CULTURAL ADVICE REPORT

J6287 - 597 East Maddisons Road, Rolleston
(RC245088)

To: Selwyn District Council

Figure 8-5: Semi-Trailer Entry to Loading Dock

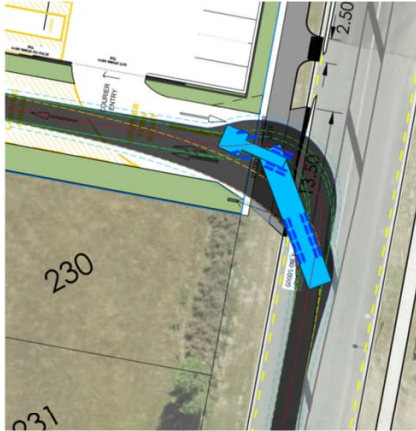
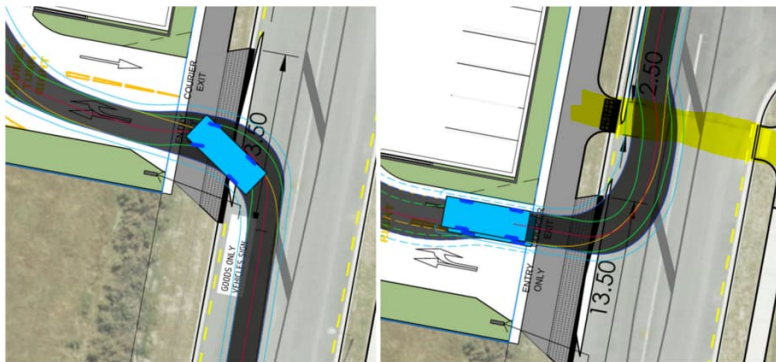
The vehicle crossing located on the extension of Shillingford Drive (provided by Arbor Green when s224 is granted) may clash with the proposed pedestrian crossing in a negative way (see image below).

The findings in the Safe Systems Audit may identify that this vehicle crossing needs to be relocate. The preference would be that the applicant would arrange with the developer of Arbor Green any relocations prior to their installation; however, to support this outcome I need a legally binding mechanism that requires the applicant to undertake all necessary alterations to the existing Council infrastructure that are pivotal to achieving safe pedestrian and road user outcomes identified in the Safe Systems Audit at their expense.
